Access Compliance Report

Public Rights-of-Way

Intersection ID: 49893	Main Street: ROCKY_FORD_CLUB_RD	Cross Street: RIDGEVIEW_COMMONS_DR	Location: E
ADA ID: C780006CC881	Ramp Type: PerpDiag	Initial Pass/Fail: Pass	Overall Compliance: No
Severity Score: 7.5			
Codes/Mitigation Info/Possible Solution		Field Measurements/Component Compliance

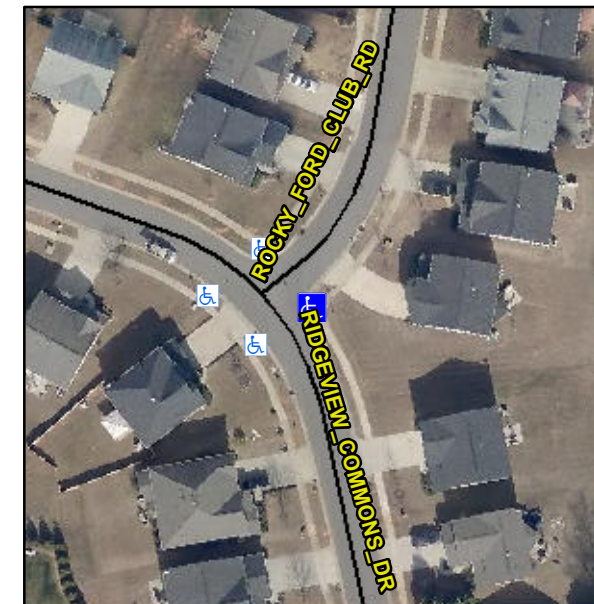
Not Found, R304.2.1, R302.7.2

Compliance	Description	Data	Compliance	Description	Data
N/A	Ramp Length (in)	66.5	Yes	Ramp Slope (%)	5.8
Yes	Ramp Width (in)	48.0	Yes	Ramp XSlope (%)	1.7
N/A	Flare Type LT	Sloped	N/A	Flare Type RT	N/A
N/A	Flare Slope LT (%)	6.5	Yes	Flare Slope RT (%)	2.1
N/A	Flare Traversable LT?	Yes	N/A	Flare Traversable RT?	Yes
Yes	Landing Length (in)	48.0	Yes	DWS Provided?	Yes
No	Landing Width (in)	37.5	Yes	DWS Contrast?	Yes
Yes	Landing Slope (%)	0.5	Yes	DWS Length (in)	24.5
Yes	Landing X Slope (%)	1.0	Yes	DWS Full Width?	Yes
N/A	Landing Curb? (Y/N)	No	Yes	DWS Offset (in)	1.5
N/A	Shared Landing?	Yes			
Yes	Gutter Ponding?	No	Yes	Gutter Slope (%)	2.1
No	Gutter Lip Ht (in)	0.5	Yes	Gutter X Slope (%)	0.2
N/A	Painted X Walk1?	No	N/A	Painted X Walk2?	No
	X Walk 1 Direction	To NW		X Walk 2 Direction	To SW
N/A	X Walk 1 Width (in)	N/A	N/A	X Walk 2 Width (in)	N/A
	X Walk 1 Slope (%)	3.2		X Walk 2 Slope (%)	2.0
	X Walk 1 X Slope (%)	1.0		X Walk 2 X Slope (%)	1.2

Remove & Replace Curb Ramp With Two New Directional Ramps or Equivalent.
